PRODUCT ADVISORY

Bar Code Label Change for Intersil's UL Recognized Components

**Refer to:
PA12047**

Date: June 21, 2012

PA12047 – Inner/Intermediate Bar Code Label

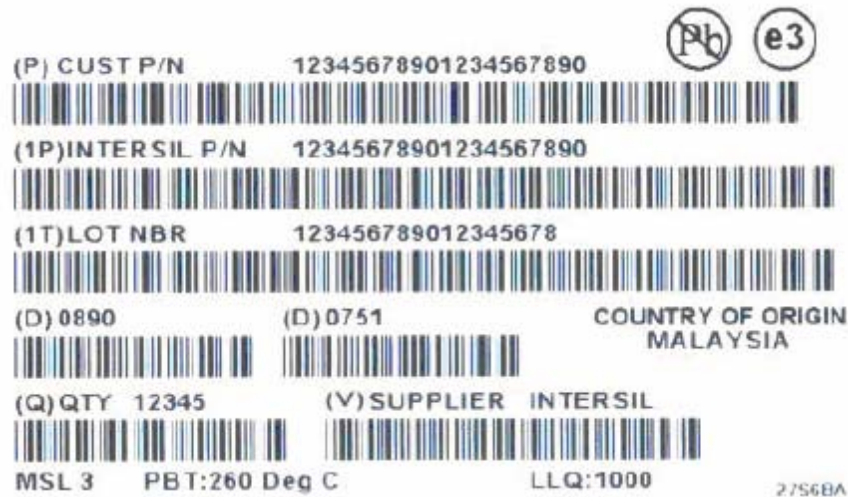
This advisory is to inform you that Intersil has implemented the use of a new inner/intermediate bar code label for the packing/shipping of its UL (Underwriters Laboratory) recognized components. The inner/intermediate bar code label has been updated to include the electrical rating and UL recognized component mark. Examples of the current and new bar code labels are included on the next page for reference. Implementation of the new bar code label for packing/shipping began in May 2012.

New – Label (changed areas circled in red)
